CHANGE BULLETIN 02 **F.G.A. No. 21003**

ROOMS TO GO – OFFICE RENOVATION & EXPANSION
Seffner, Florida

February 8, 2022

SHEET NUMBER
G3.01

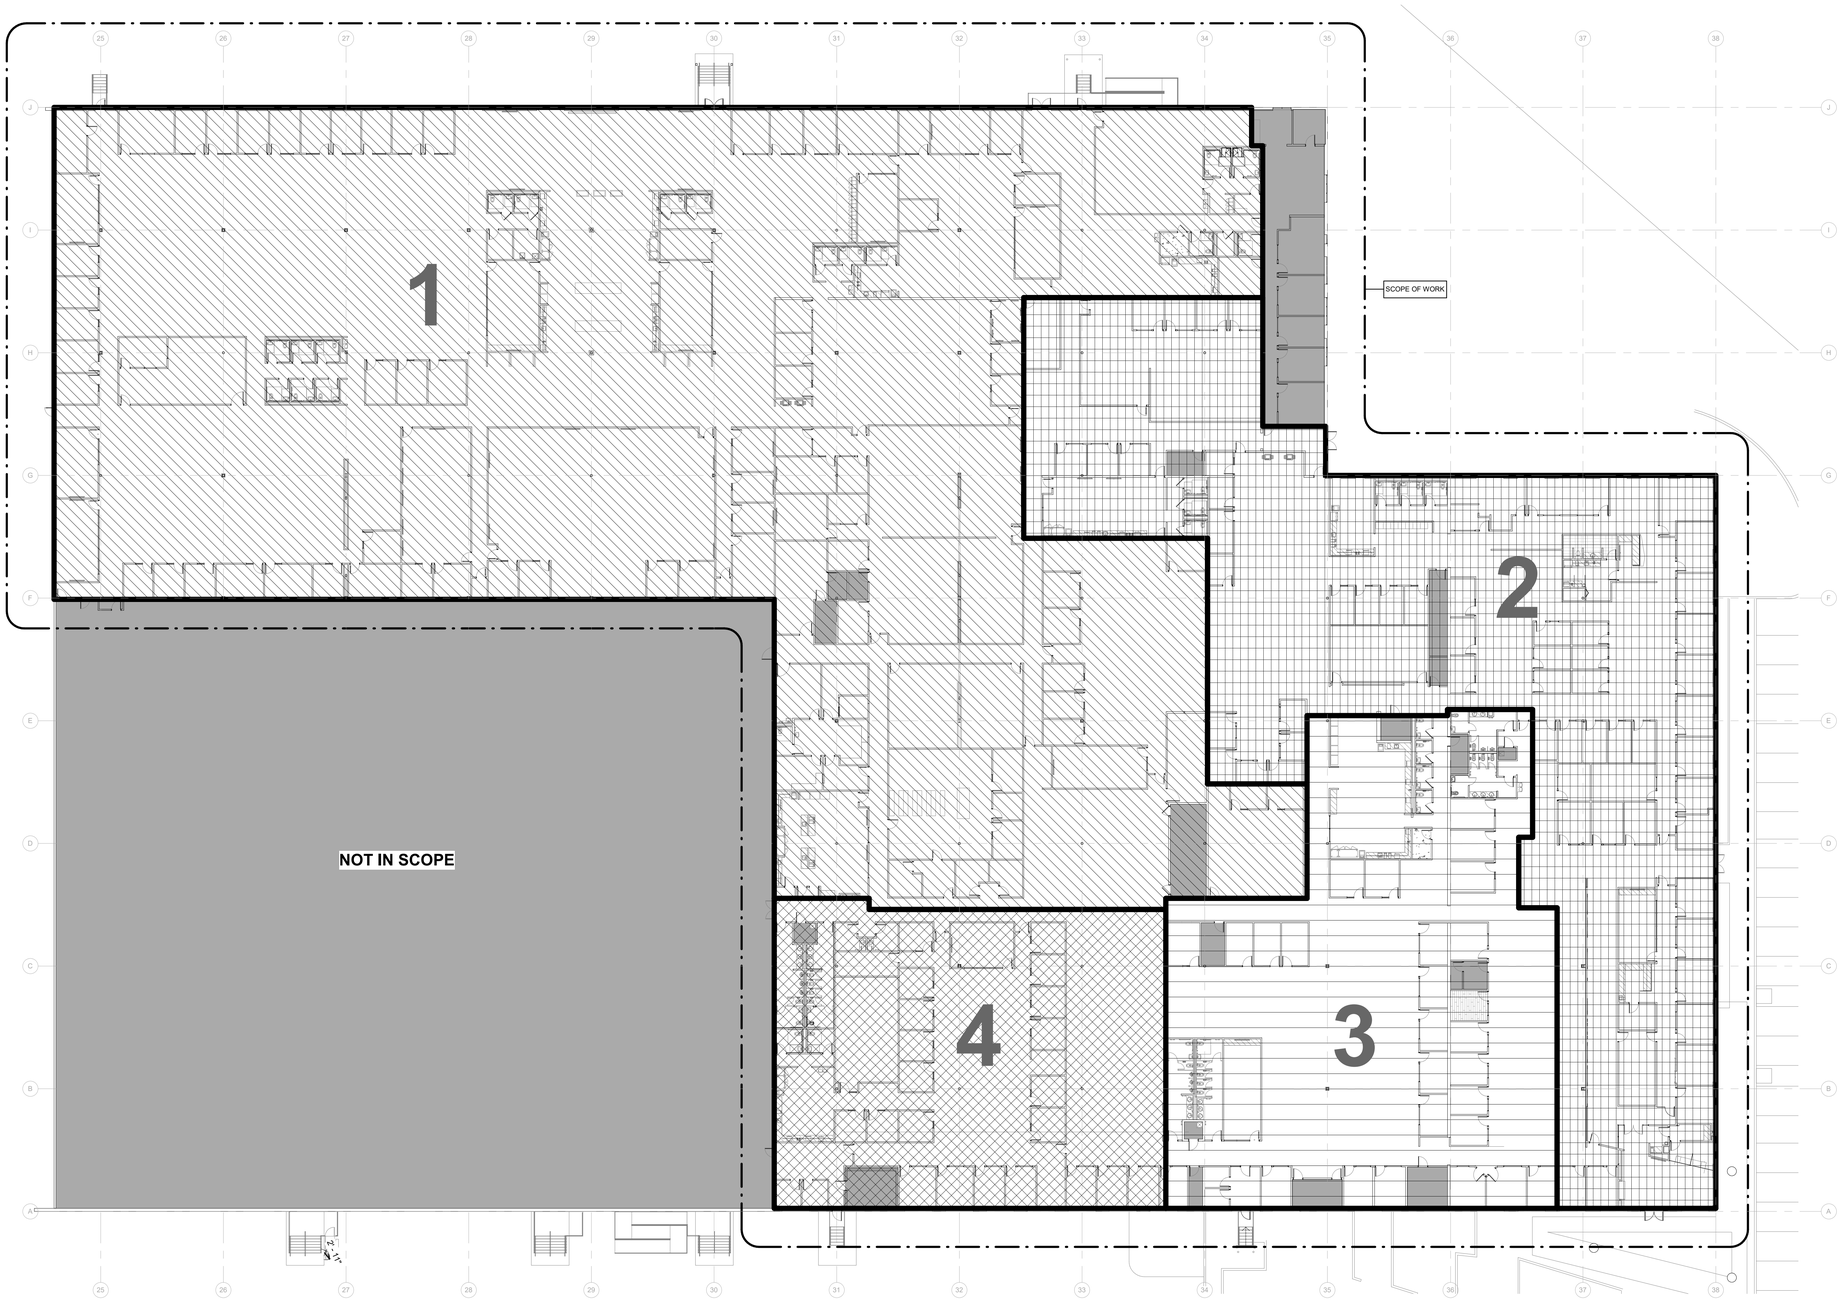
Item 5: Refer to Sheet G3.01– Overall Phasing Plan
ADD sheet G3.01 Phasing Plan
Phase 1: Duration 5 months (150 calendar days)
Phase 2: Duration 3 months (90 calendar days)
Phase 3: Duration 2 ½ months (75 calendar days)

Phase 4: Duration 1 ½ months (50 calendar days)

Total Duration of Project: 12 months (365 calendar days)

CONSTRUCTION PLAN B
1/8" = 1'-0"

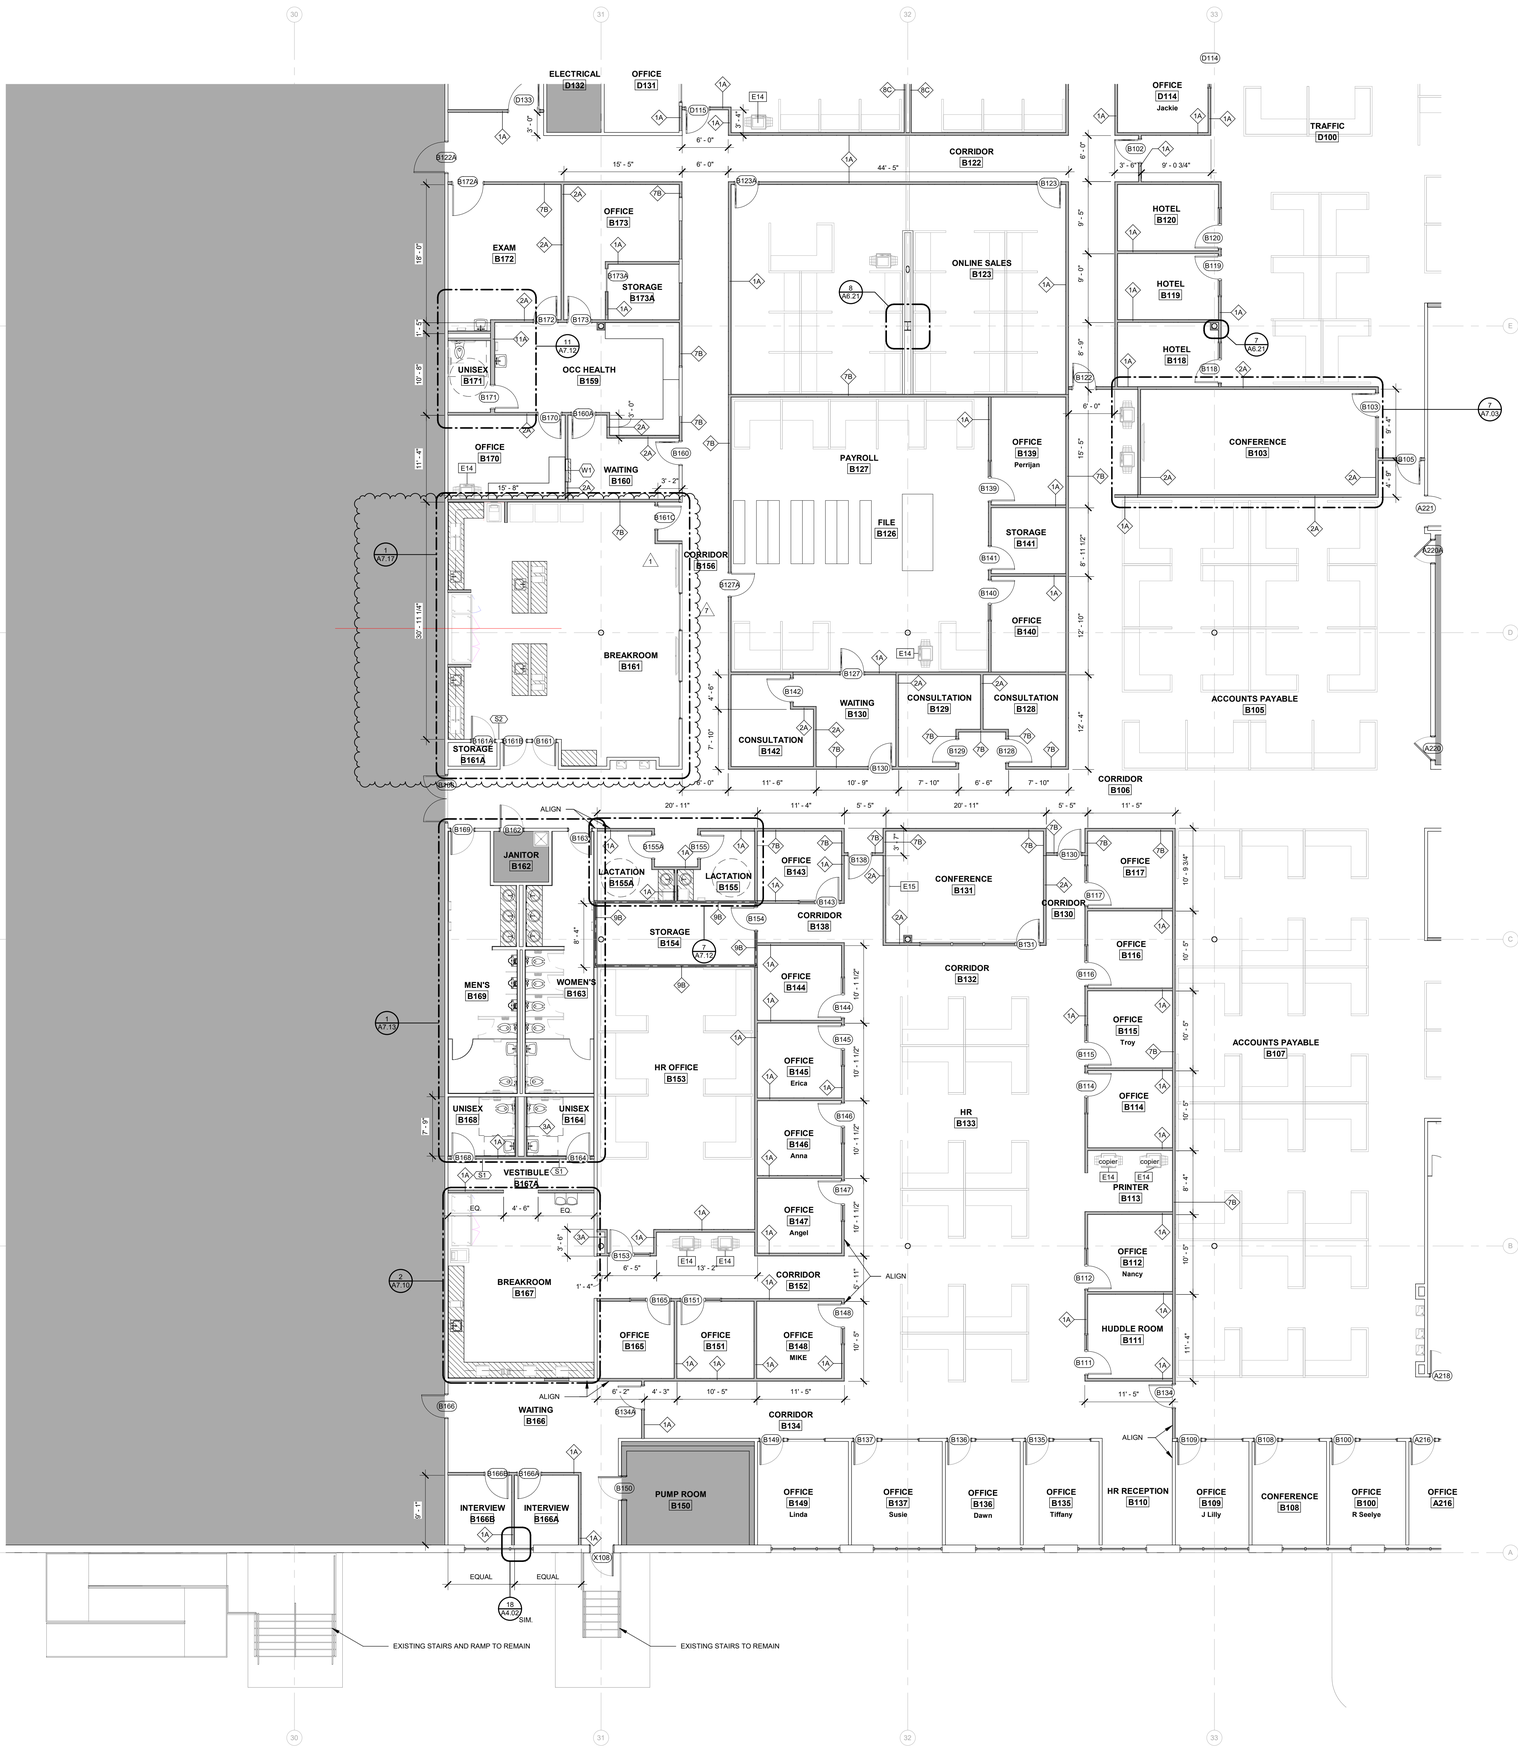
Item 7: Refer to Sheet A2.10B – Construction Plan B
ADD new millwork, sinks, equipment, and televisions to Break Room 161.

CONSTRUCTION PLAN E 1
1/8" = 1'-0"

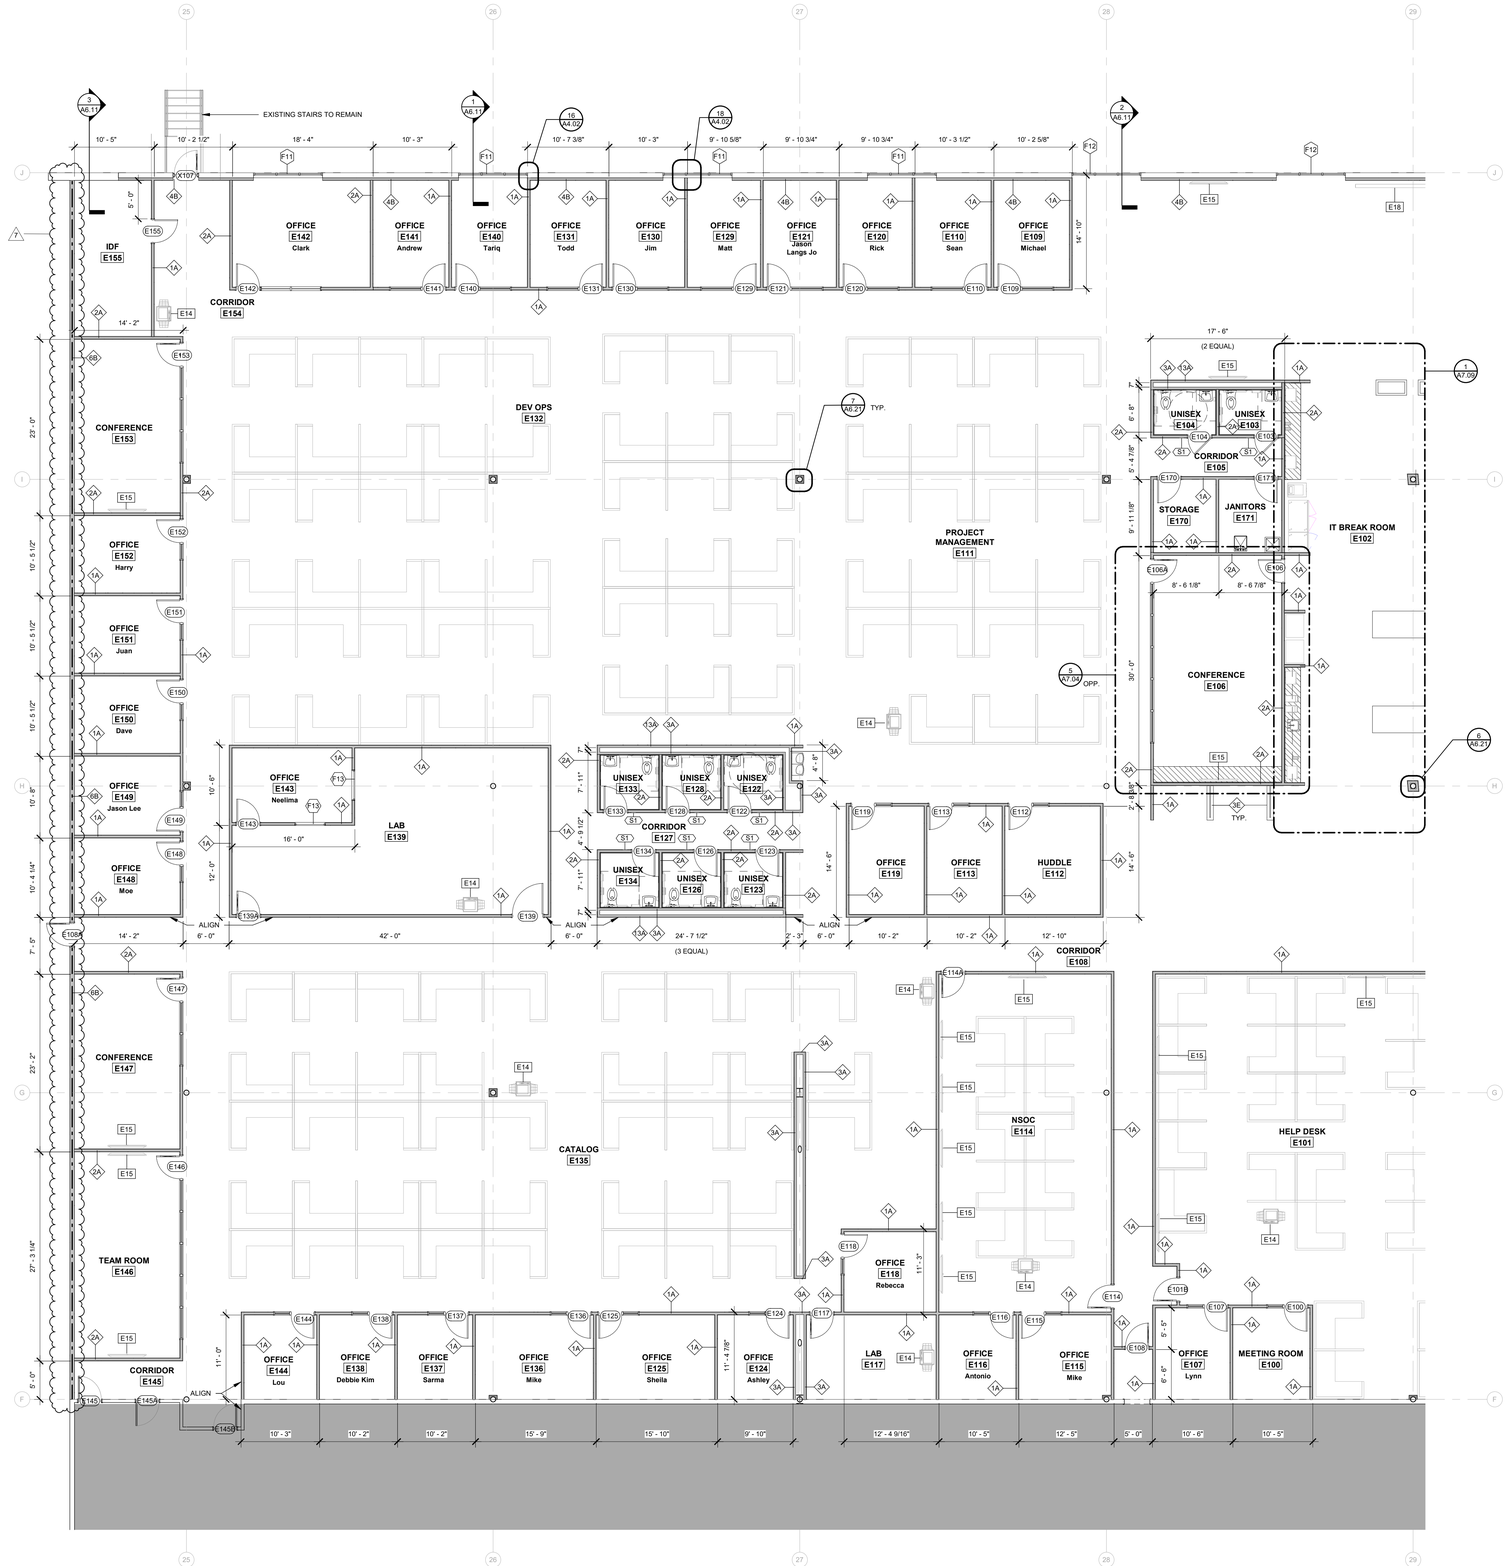
Item 8: Refer to Sheet A2.10E – Construction Plan E
CHANGE wall between warehouse and new office build-out to a 1hr rated wall.

FIRST FLOOR REFLECTED CEILING PLAN B (1)
1/8" = 1'-0"

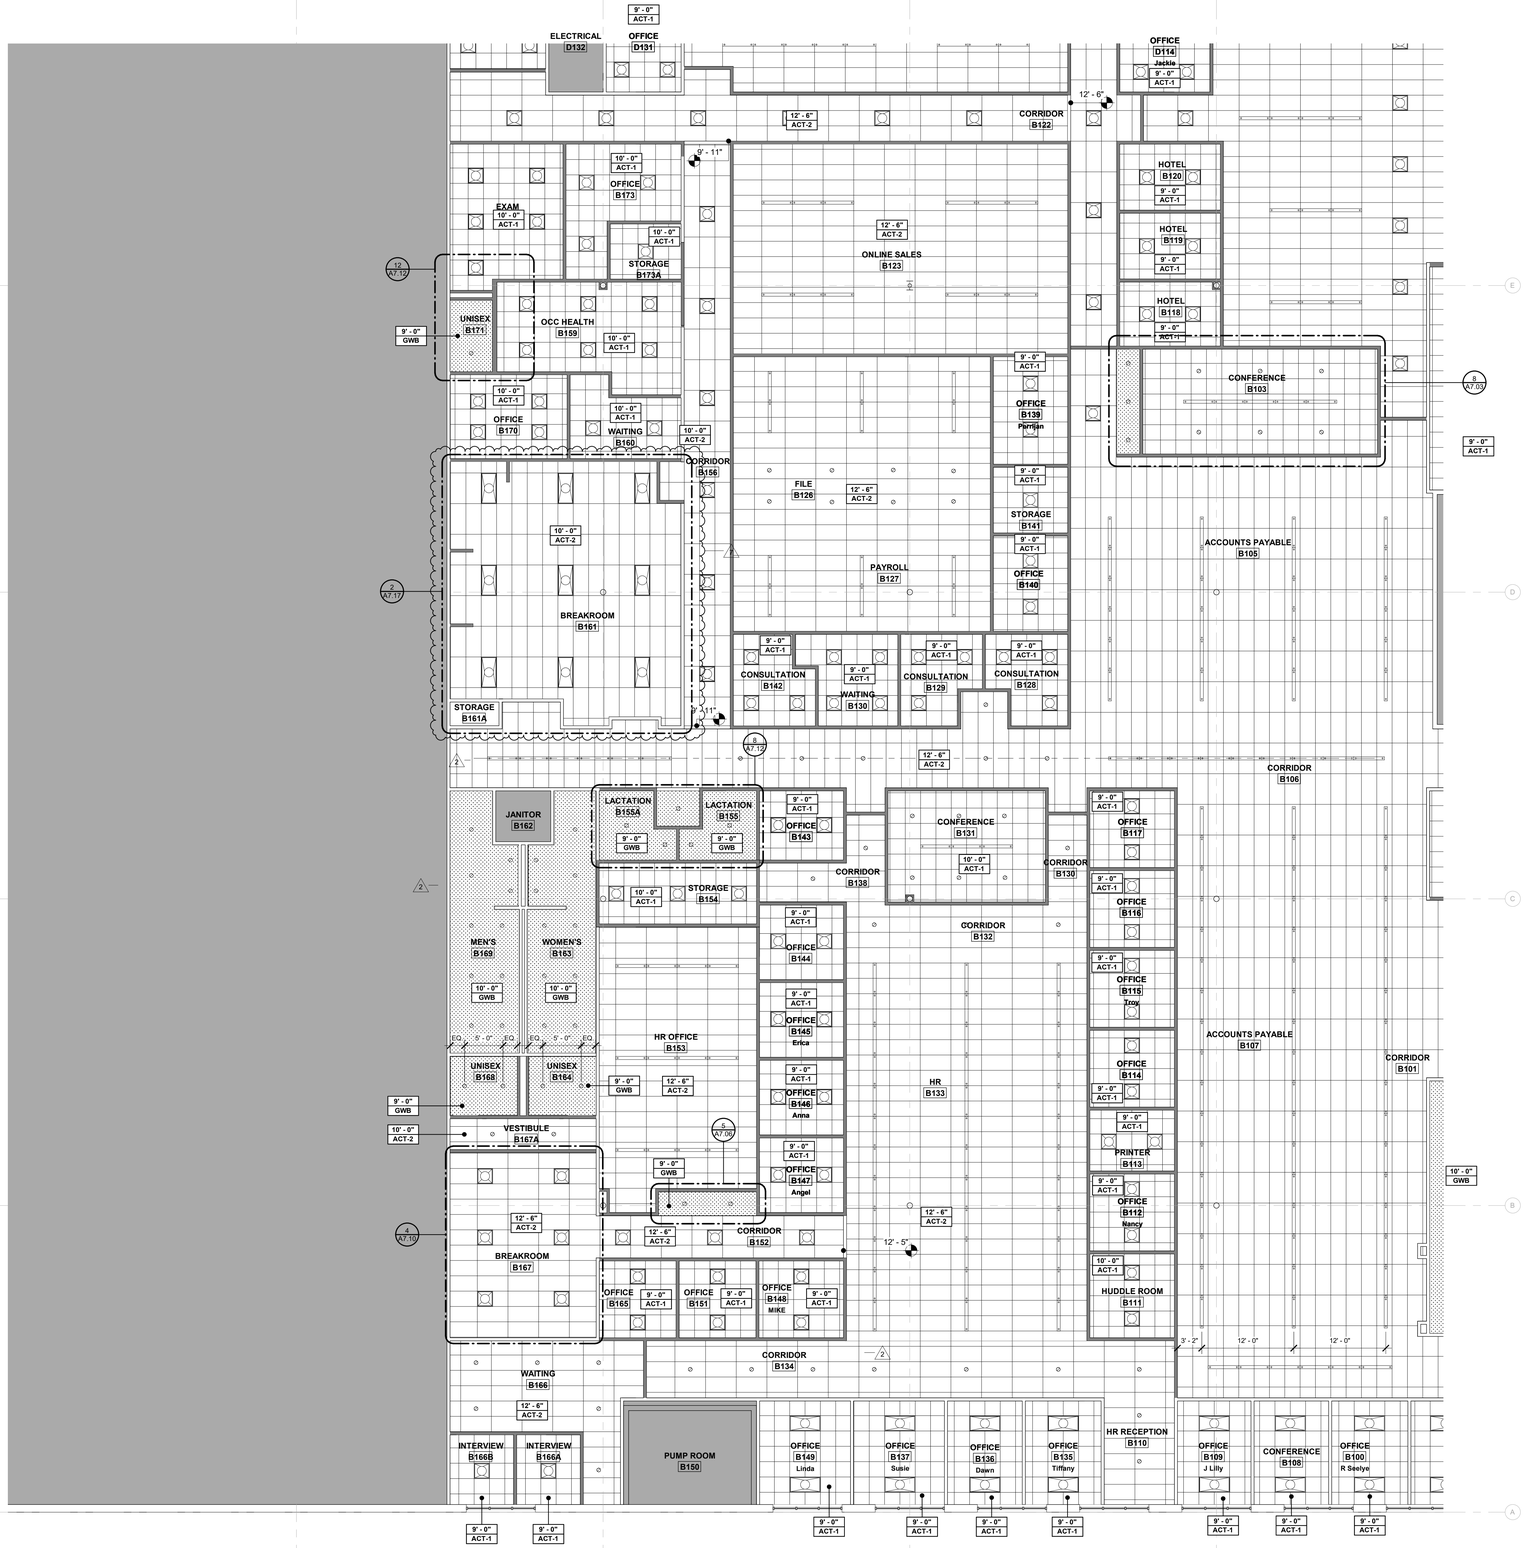
Item 13: Refer to Sheet A8.01B – Reflected Ceiling Plan B
CHANGE ceiling grid from ACP-1 to APC-2. Adjust lights for removal of soffit.
